HISTORIC PRESERVATION COMMISSION

ALTERATION TO A HISTORIC PROPERTY STAFF REPORT

Site: 178 Central Street c.1840 Adams-Locke House

Case: HPC 2016.027 Single Building Local Historic District

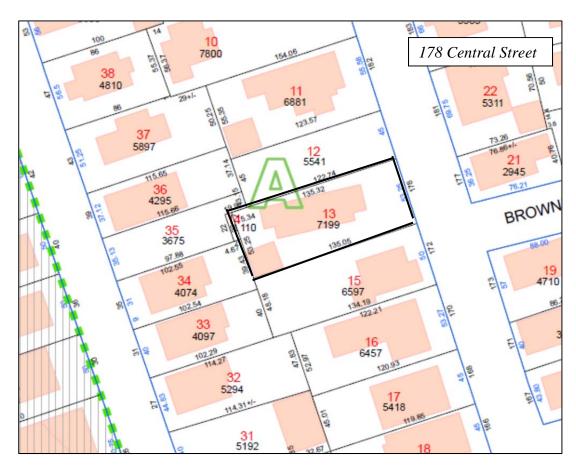
2. Whenever possible, repair and retain original or later important window elements such as sash, lintels, sill, architraves, glass, shutters and other decorative elements and hardware. When replacement of materials or elements is necessary, it should be based on physical or documentary evidence ...

The Applicant finds the windows do not stay up and currently uses improvised supports hold the windows open.
